GRADING AND EROSION CONTROL PLANS

THE COMMONS AT FALCON FIELD - FILING NO. 1

EPC FILE NO.: SF2435

ISSUE	DATE
INITIAL ISSUE	12/13/24
RESUBMITTAL	3/13/26
DESIGNED BY:	TDM
DRAWN BY:	GES
CHECKED BY:	TDM
FILE NAME:	21604-01ECCV

INITIAL/INTERIM
EROSION
CONTROL PLAN

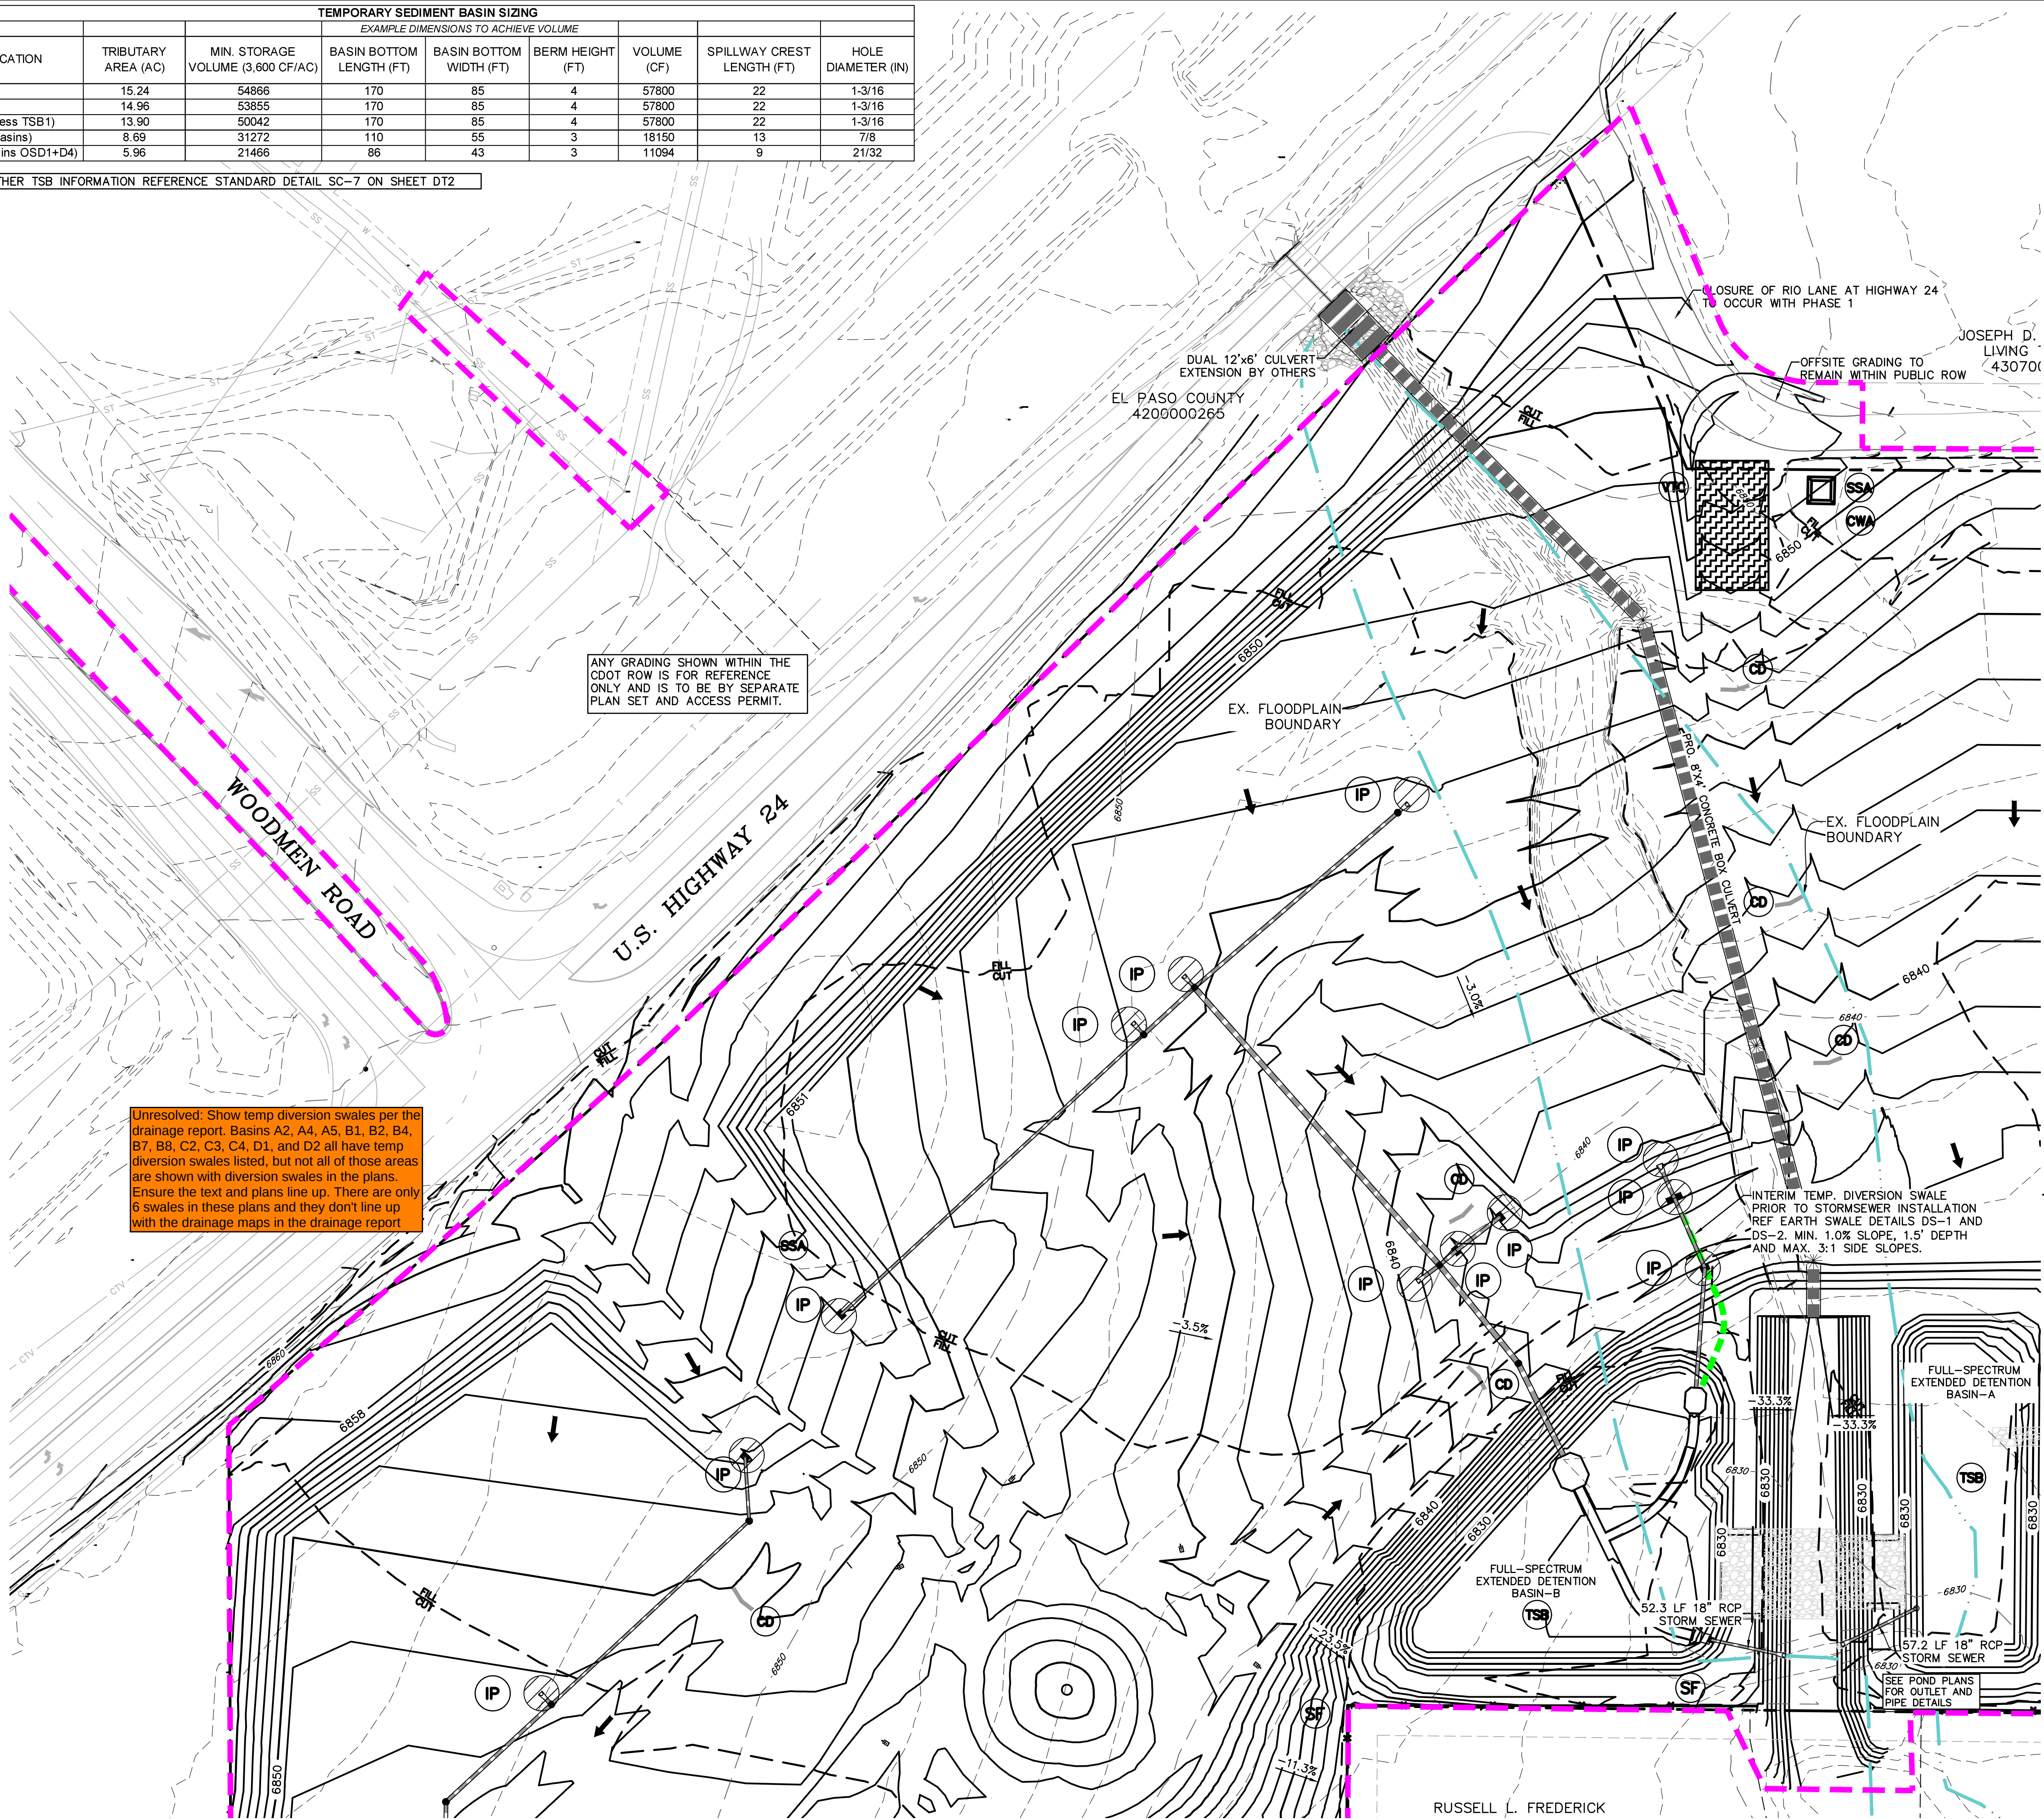
Unresolved: Show temp diversion swales per the drainage report. Basins A2, A4, A5, B1, B2, B4, B7, B8, C2, C3, C4, D1, and D2 all have temp diversion swales listed, but not all of those areas are shown with diversion swales in the plans. Ensure the text and plans line up. There are only 6 swales in these plans and they don't line up with the drainage maps in the drainage report.

INITIAL/INTERIM EROSION CONTROL PLAN

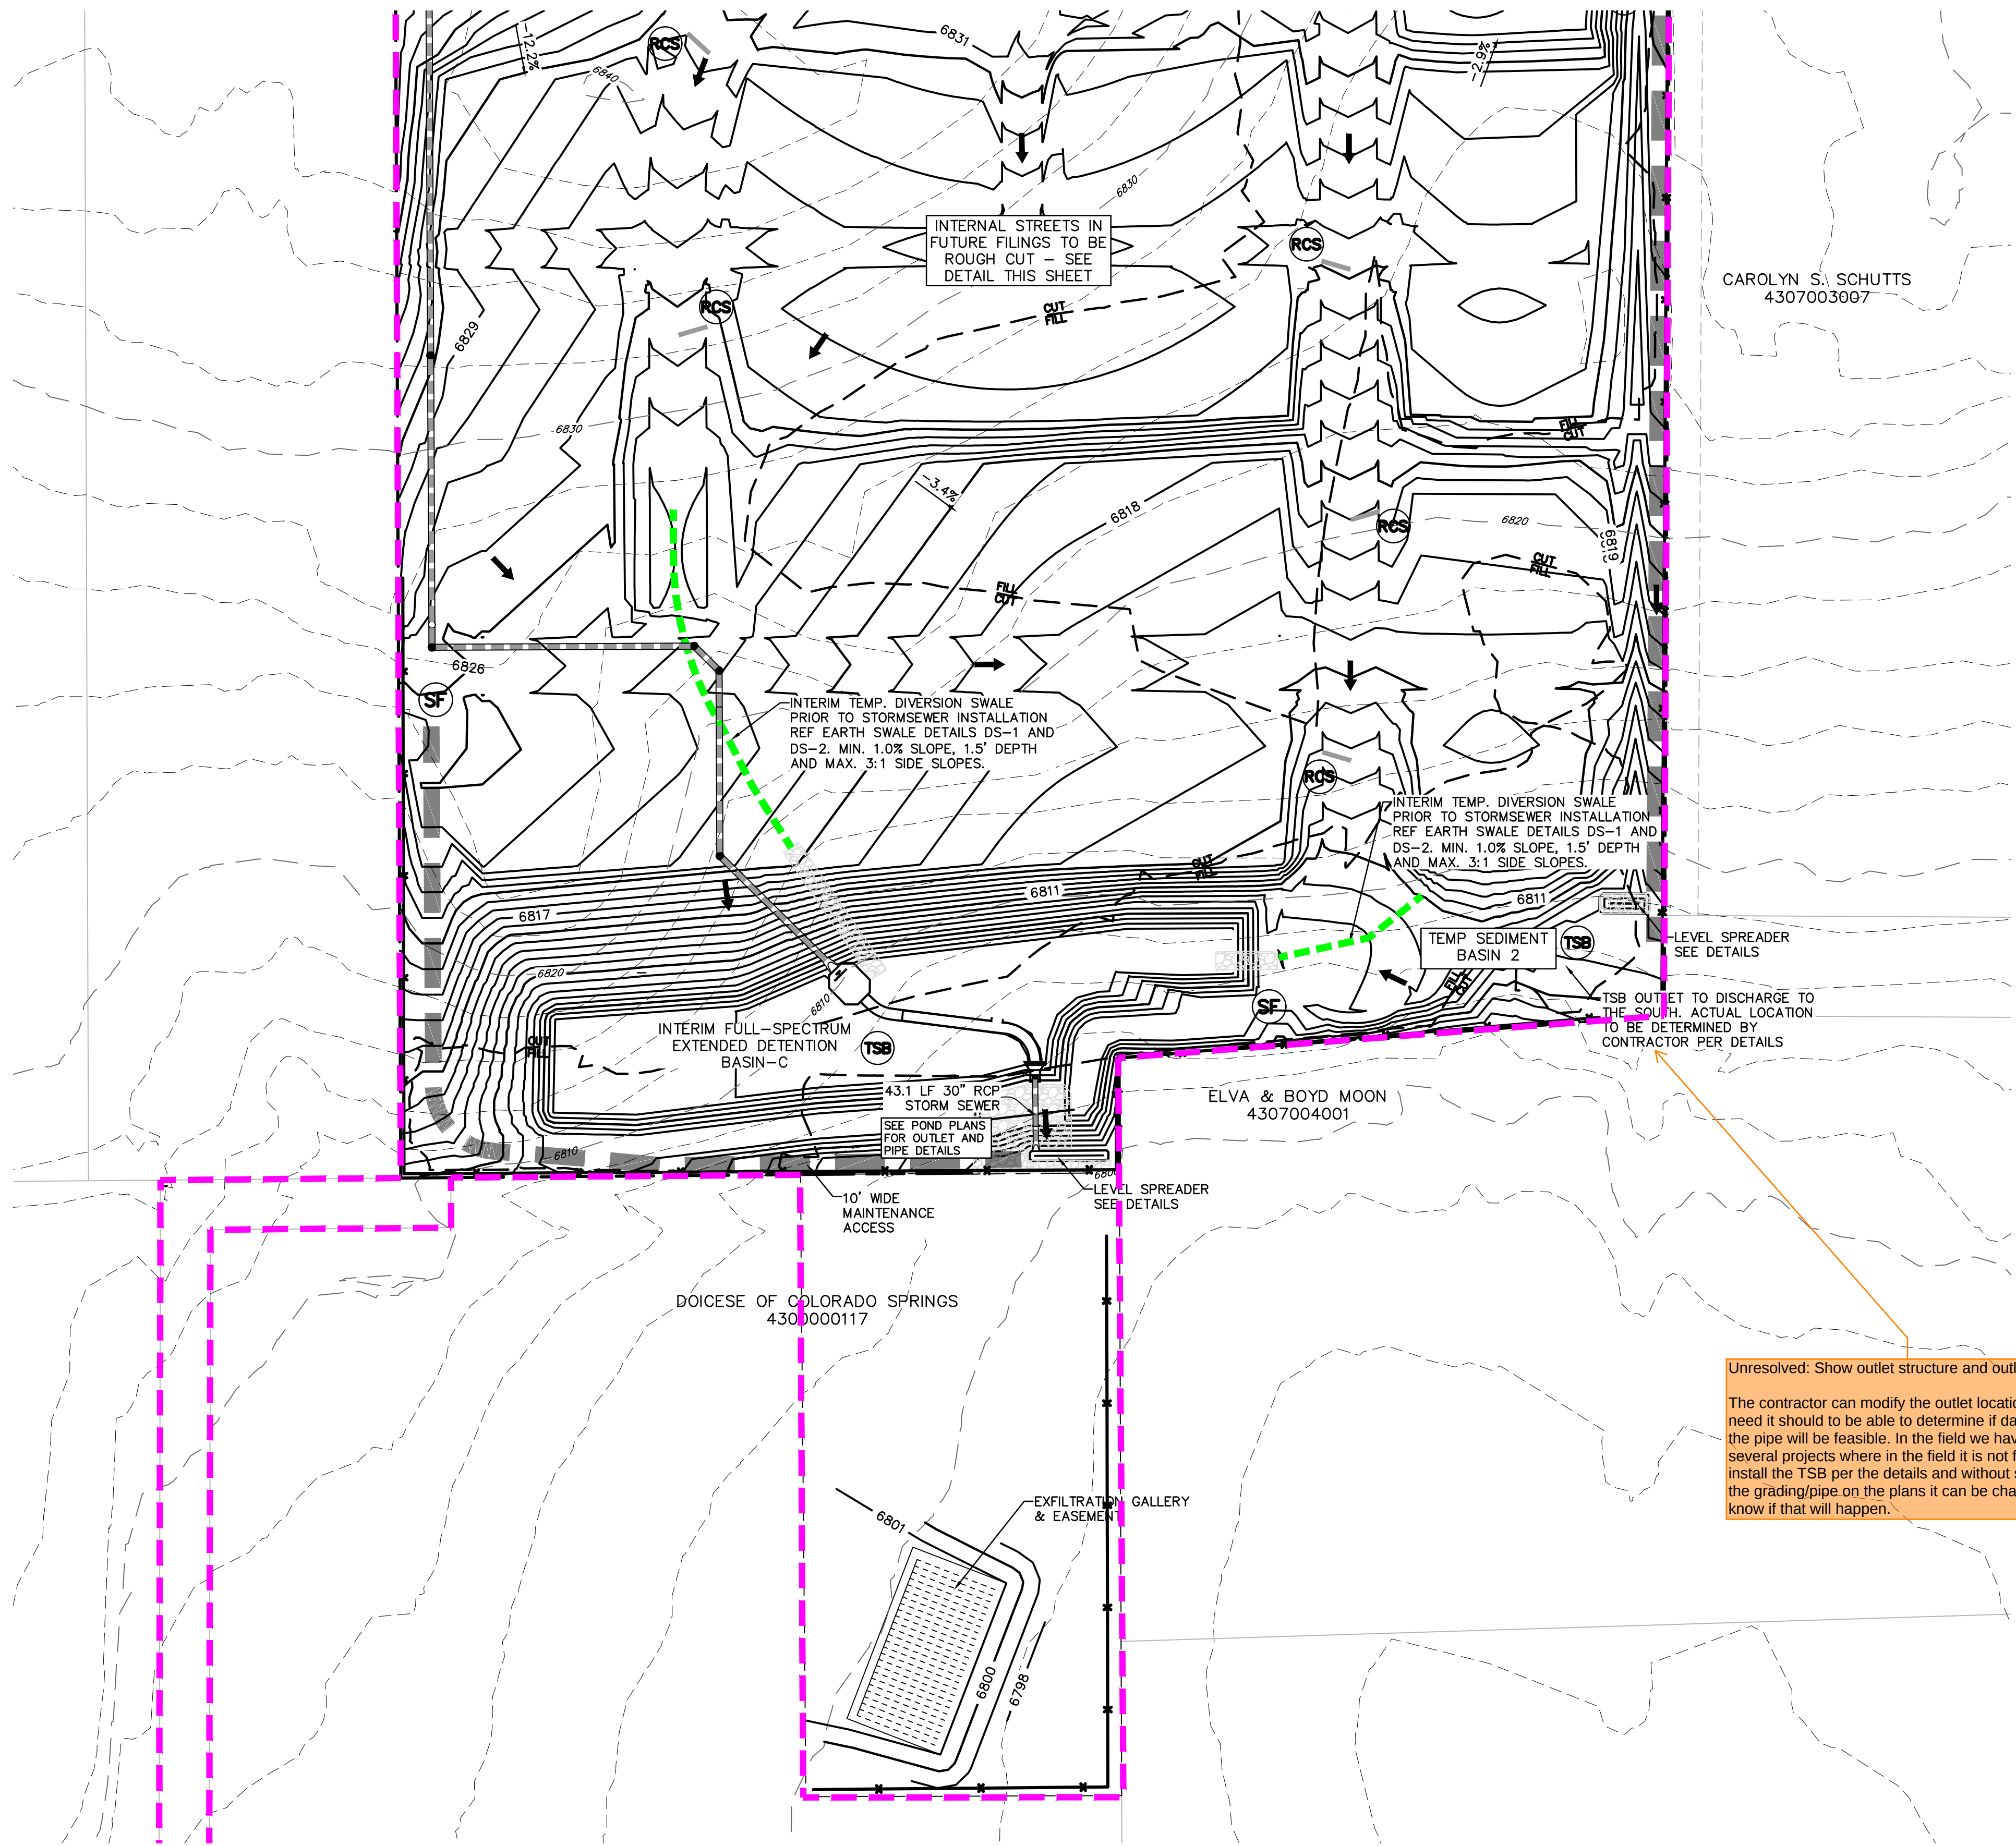
Unresolved: Show outlet structure and outlet pipe.

The contractor can modify the outlet location but we need it should be able to determine if daylighting the pipe will be feasible. In the field we have had several projects where in the field it is not feasible to install the TSB per the details and without showing the grading/pipe on the plans it can be challenging to know if that will happen.
